Item #1

TO: Architectural Review Board
FROM: Erik F. Nelson, Senior Planner
DATE: 8 February 2016
RE: **121 Caroline Street – Exterior Alterations**

NEW PORCH
121 CAROLINE STREET

Side Elevation

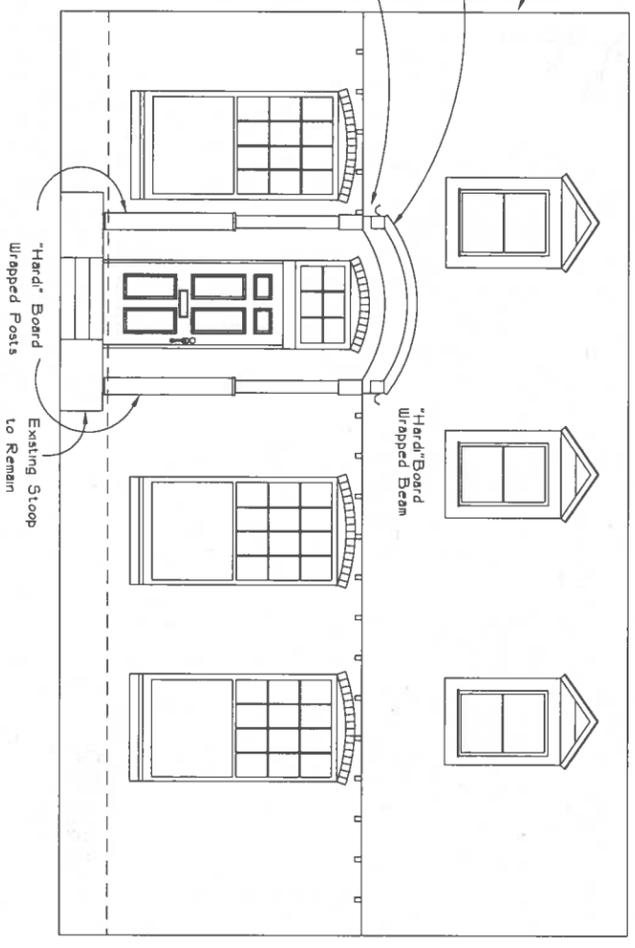
The applicant proposes to remove the pilasters on either side of the door (installed in the 1990s) and construct a small front porch, in order to protect the front entryway from the weather. At its meeting on January 11, the Board expressed concern about the large arched panel that would have faced the street. The applicant has responded by lowering the new roof, which has reduced the size of the arched panel. The potential for placing the new porch cover under the existing roof overhang was another question raised, but that configuration is not feasible due to insufficient clearance. There was also a comment that an arched porch cover was not consistent with the Colonial Revival style of the building. The arched porch cover reflects the arched windows of the first story and is a clear delineation of the building's evolution, as suggested by Standard #9.

1. The property will remain in residential use.
2. The distinguishing original qualities and character of the building are its form and materials. Installation of an arched roof to protect the front entry door will compliment rather than adversely impact those characteristics.
3. The proposed front porch will not suggest an earlier period of construction.
4. The pilasters at the front entry have no discernible function, aside from decoration, and are not thought to have acquired significance in their own right.
5. The distinctive features of the building – its brickwork, arched windows, and roof form – will be treated with sensitivity. The new arched porch roof reflects (and respects) the arched windows of the first story.
6. Not applicable.

Staff finds the proposed front porch to be architecturally compatible with the historic aspects of the Historic District and recommends approval of the revised drawings (undated).
